## BULLETIN NO. 212A

**MACHINE:** Auto-Lift S/N 200 through 550

**SUBJECT:** FUEL TANK LEAKS

Muffler Side

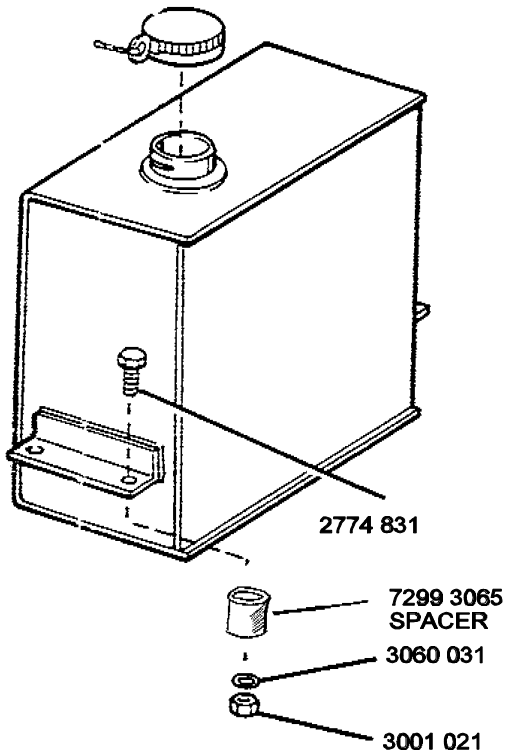
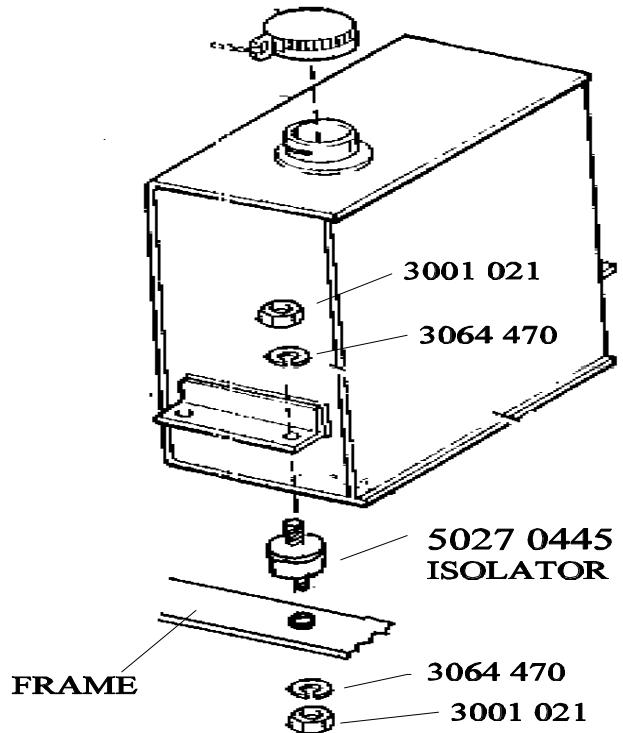
We have received reports that a vibration problem has caused fuel tanks to crack.

To solve this problem, the capscrews holding the tank in place have been replaced with two steel spacers (Nordco p/n 7299 3065) on the muffler side of the tank, and vibration isolators (Nordco p/n 5027 0445) on the hydraulic tank side. See Figures and Bill of Material on other side of page.

Please note that investigation has proved that use of vibration mounts on all four corners of the tank will cause the tank to rub on the frame. In order to stop the cracking of the tanks and eliminate tank “wobble”, the combination of spacers and isolators is required.
